THE RURAL PLANNING --- PRACTICE

**OBJECTION TO PLANNING APPLICATION
SWALCLIFFE PARK EQUESTRIAN – 14/01762**

Prepared by: **Matthew Sweet** Date: **14 August 2014**
Project **Swalcliffe Park Equestrian Events** Ref: **4214**
For: **Partway House, Elm Farm, Swalcliffe House Residents** Page: **1 of 13**
Subject: **Noise Levels Observed During Visits on 22 September 2013 and 1 August 2014**

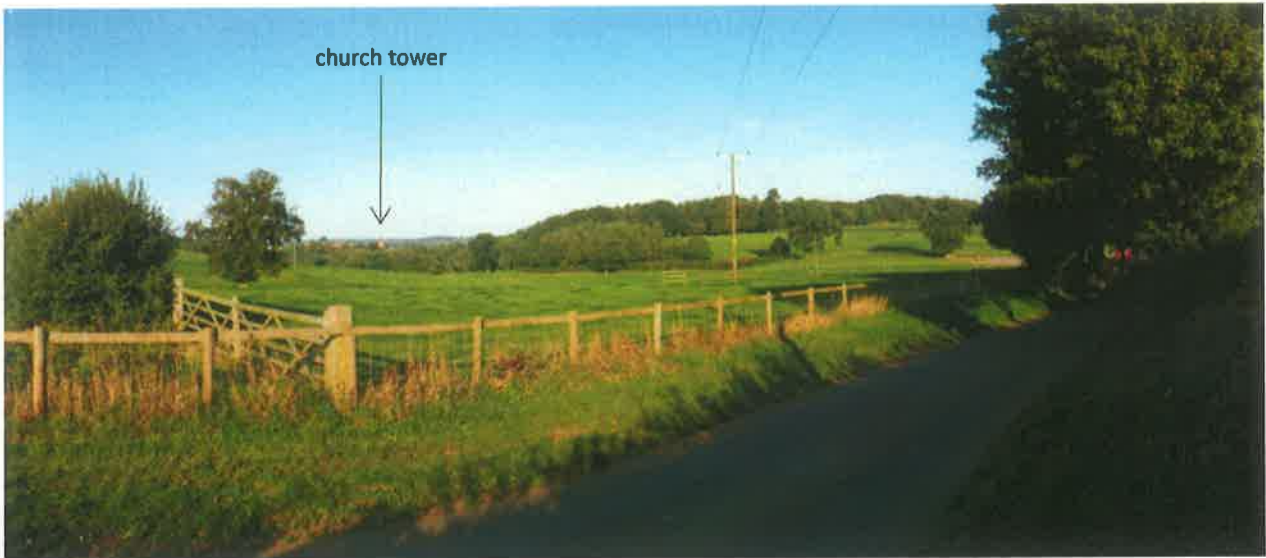
Fig.2 The Arena Field viewed from Grange Lane. This shows an attractive and largely unspoilt pastoral scene extending out into the far distance, with varied landform and a strong framework of woods and trees – all clearly visible from the lane. NB the picturesque quality added by the view of the church tower.

Fig.3 The Arena Field viewed from Park Lane near Grange Farm. Even with the flattening effect of the panoramic photo this still gives some idea of the attractively varied landform, with the combe running down to the right towards the village – all clearly visible from the lane.

Fig 10 showing Applicants' Visual Envelope Plan, overmarked in faded blue with enlarged Visual Envelope for the Top and 28-day Fields. The pink area indicates an estimated VE for the Stourwell Barn Anaerobic Digester (labelled AD site).

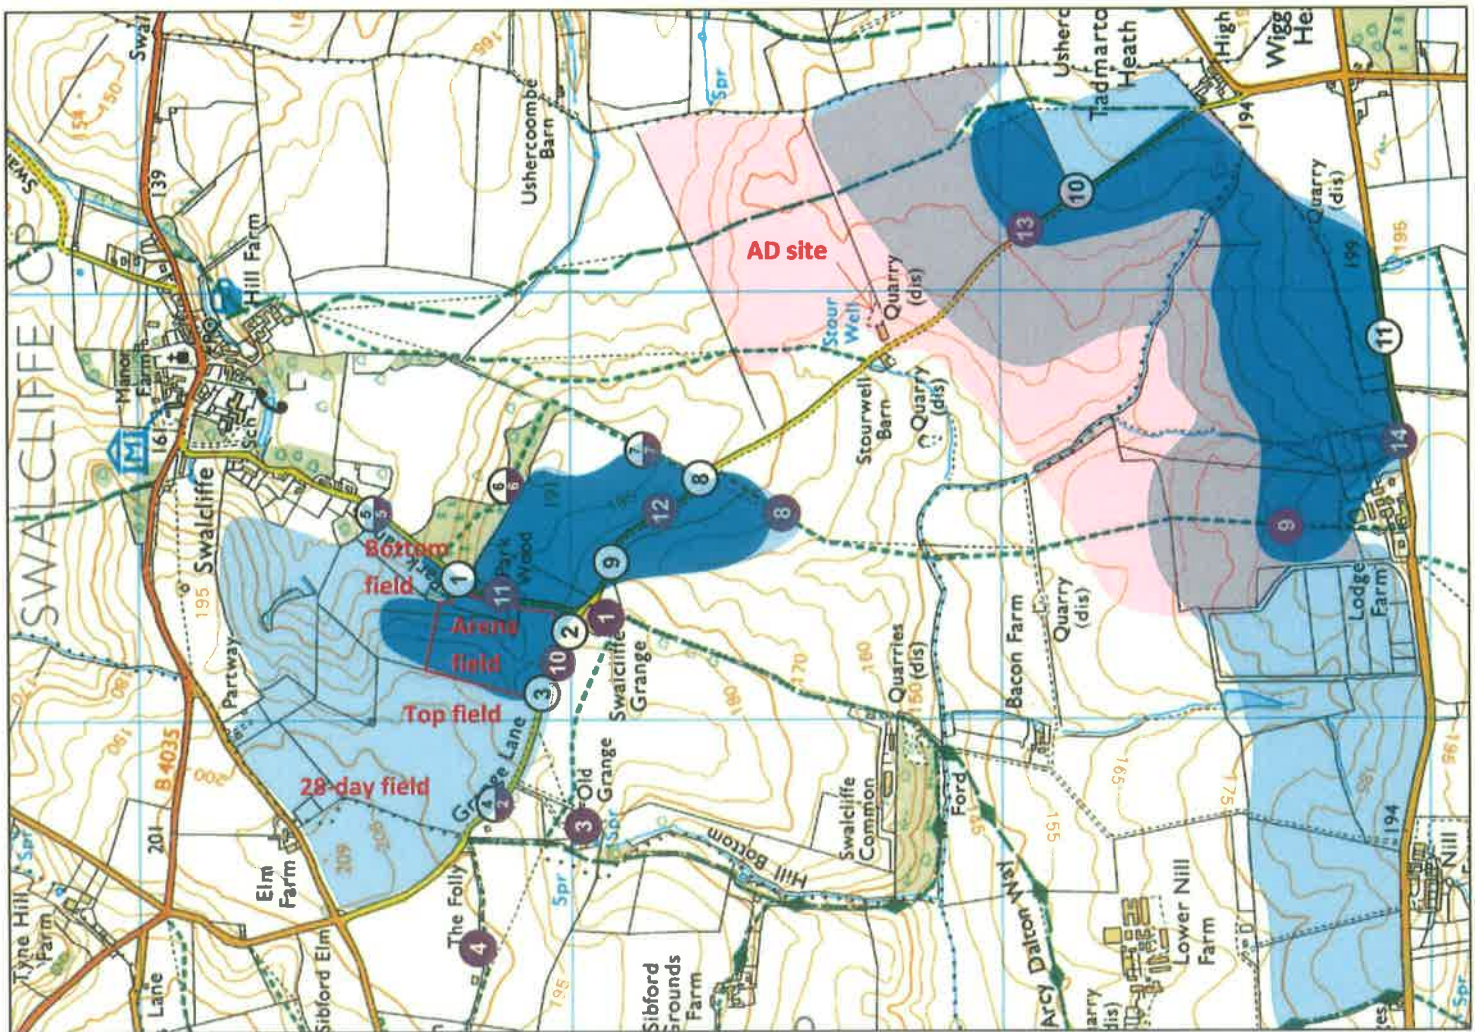
- 4.3. The extent of intervisibility with the surrounding landscape of the Arena Field illustrated on the Applicants' LVIA Plan 4 is not disputed. However it only deals with the Arena Field and does not take account of the whole Application Site. **Fig. 10** takes Plan 4 and modifies the Visual Envelope (VE) to include an estimate of land area with views of the larger Application Site.
- 4.4. This only claims to be an estimated VE area, and has therefore erred on the cautious side. What cannot be in doubt though is the substantial increase in VE, and the additional potential public vantage points from which views of the 28-Day and Top Fields are visible.
